27 February 2023

Our Ref  
P1806743JC06V01

**RE: SUPPLEMENTARY FLOOD ASSESSMENT IN RESPONSE TO SHOALHAVEN CITY COUNCIL AND BIODIVERSITY AND CONSERVATION DIVISION COMMENTS – PROPOSED EXPANSION OF SAND EXTRACTION AT PIG ISLAND, TERARA, NSW**

FL05	Map
Pig Island, Terara, NSW	Site
Expansion of Sand Extraction	Project
Flood Assessment	Sub-Project
Terara Shoalhaven Sand	Client
27/02/2023	Date

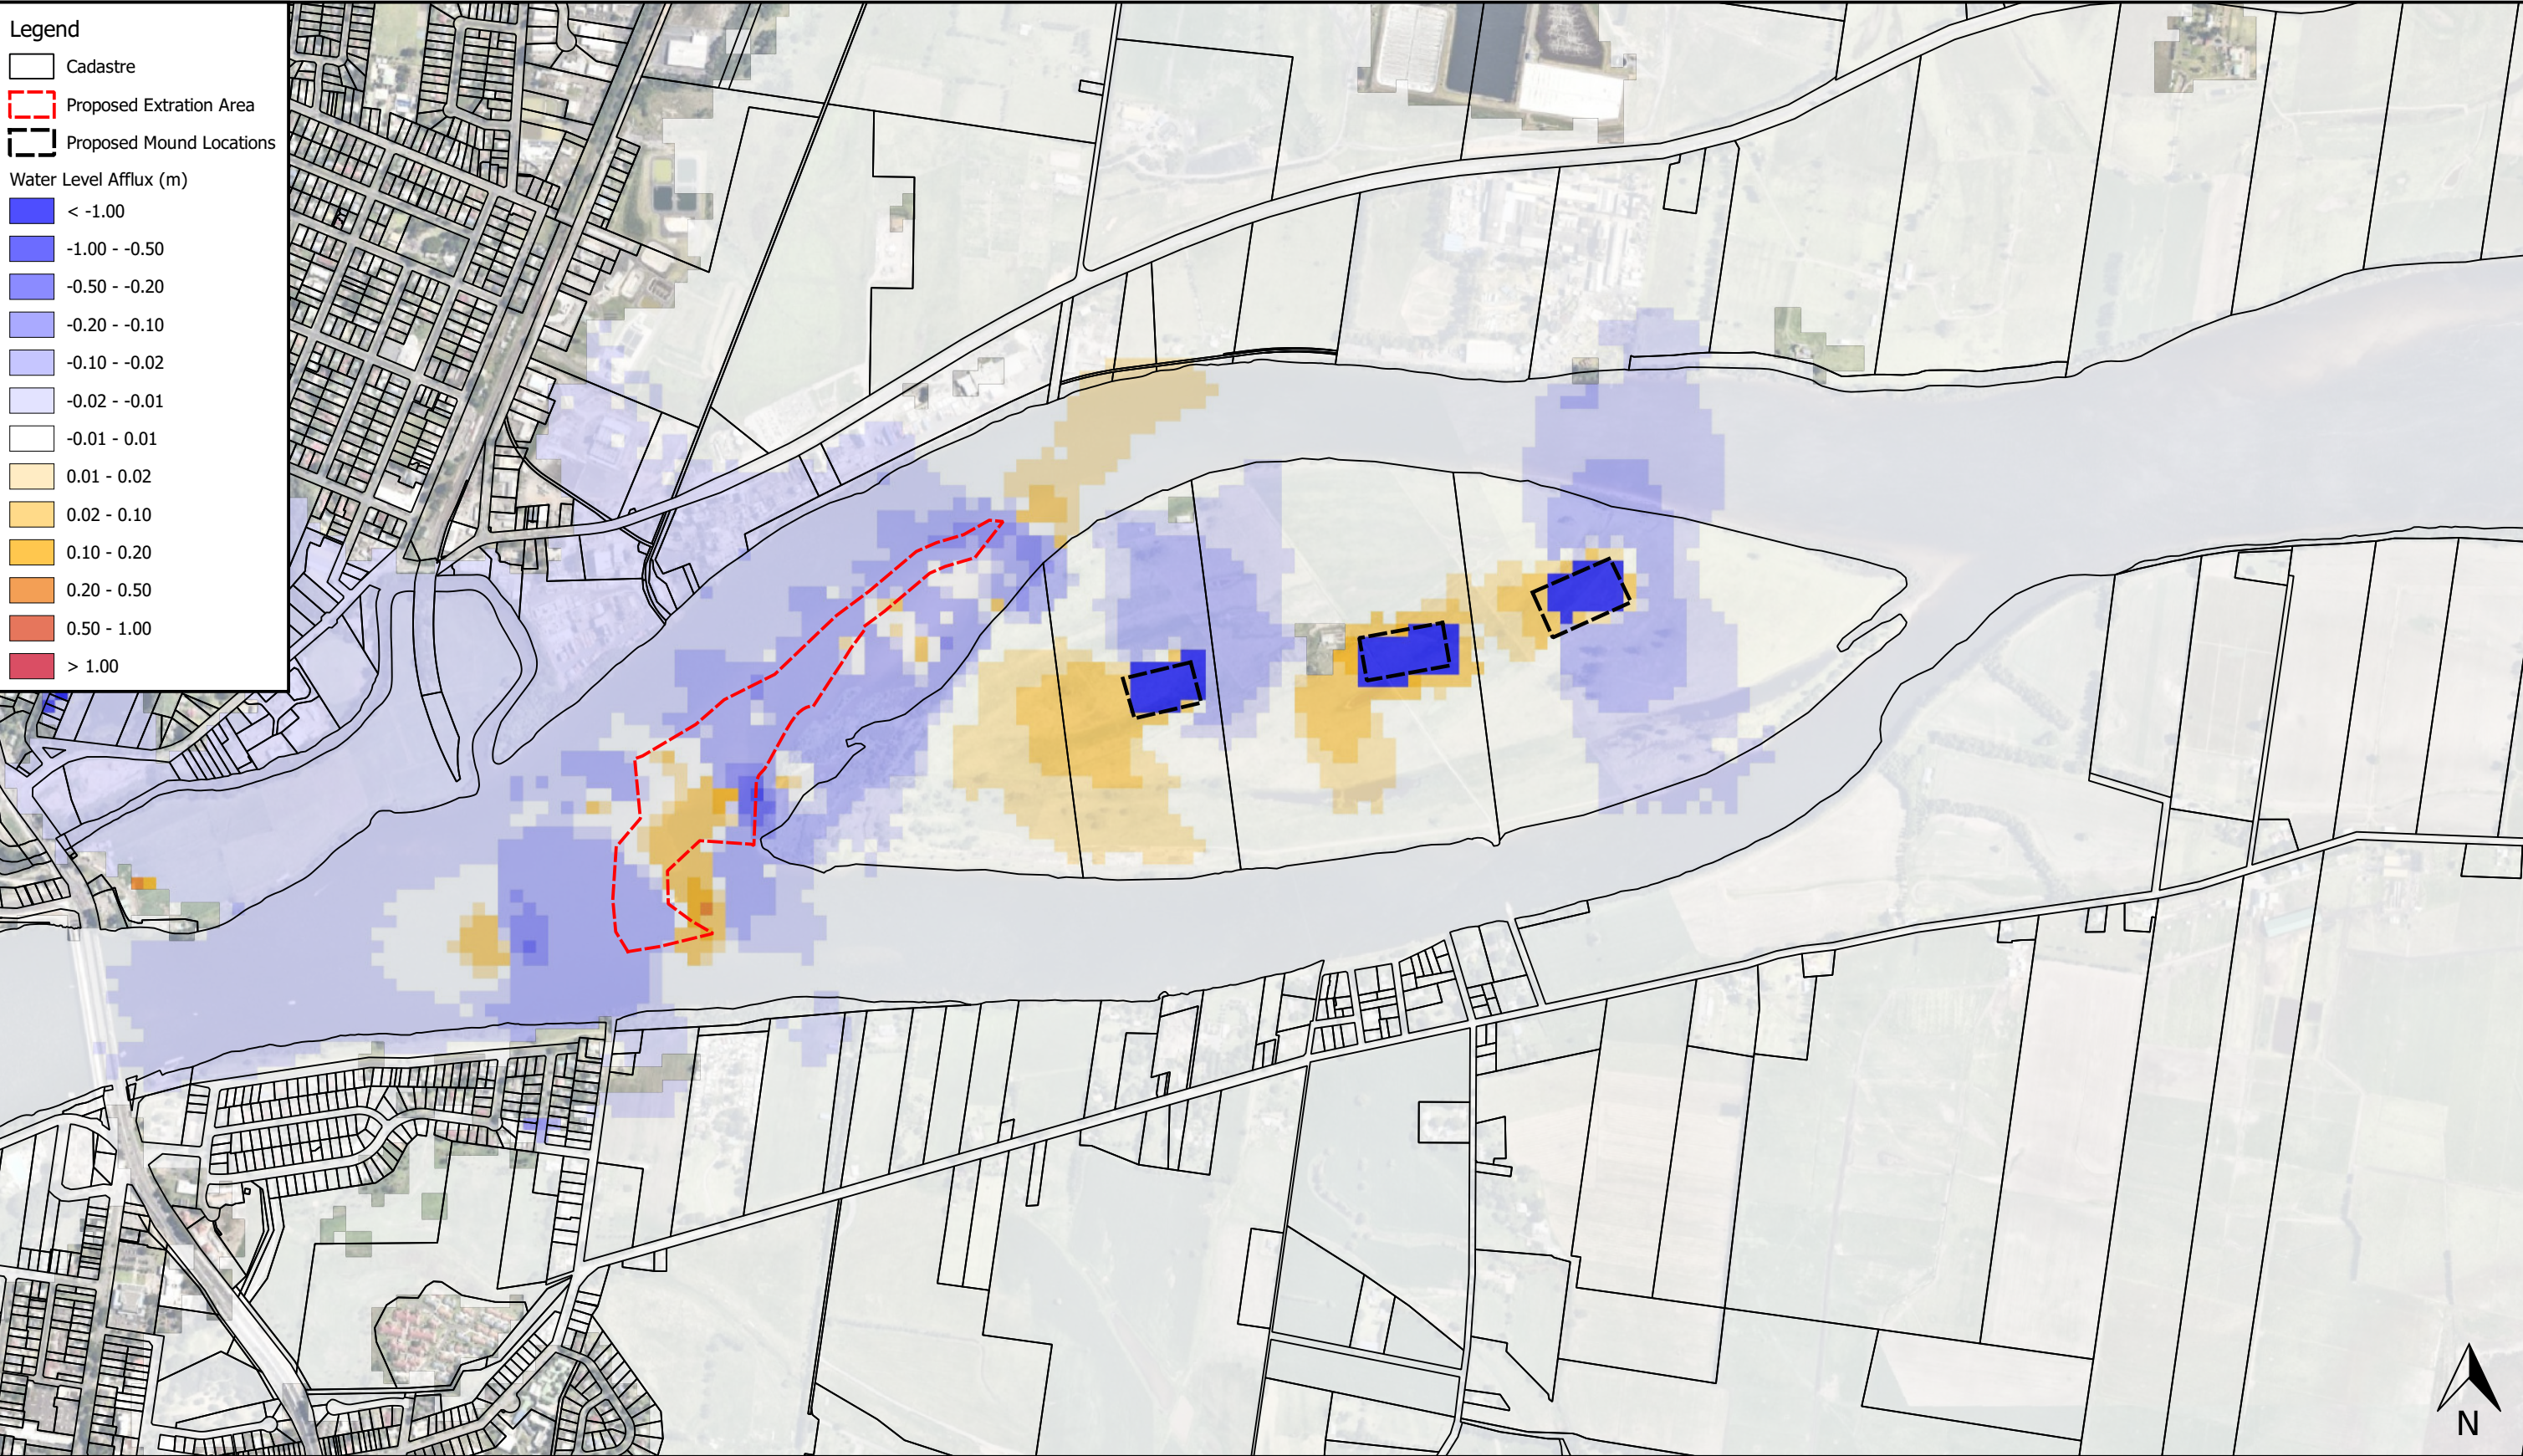
<p>18. However, as the proposed stock refuge mounds are not permissible within a High Hazard Floodway, they should be removed from the development application and the flood impact assessment revised.</p>	<p>(18) As discussed at (9).</p>
<p>19. The proposed mounds are expected to be the key contributor to any potential adverse flood impacts (water level afflux and velocity increases). Therefore, when removed from the development application it is unlikely that there would be any unacceptable adverse flood impacts.</p>	<p>(19) As discussed at (9).</p>
<p><b>Bank Erosion / Scour Impacts upon Levee Banks and other Infrastructure</b></p>	
<p>20. The initial Flood Assessment (D21/203871) included flood level afflux mapping as a result of the increased dredging extent. The mapping provided indicated local, in-stream, flood level impacts only. The report did not include flood velocity afflux mapping.</p>	<p>(20) See Attachment A, Map FL03, Map FL05, Map FL07, Map FL09 &amp; Map FL11 for the full range of velocity afflux maps.</p>
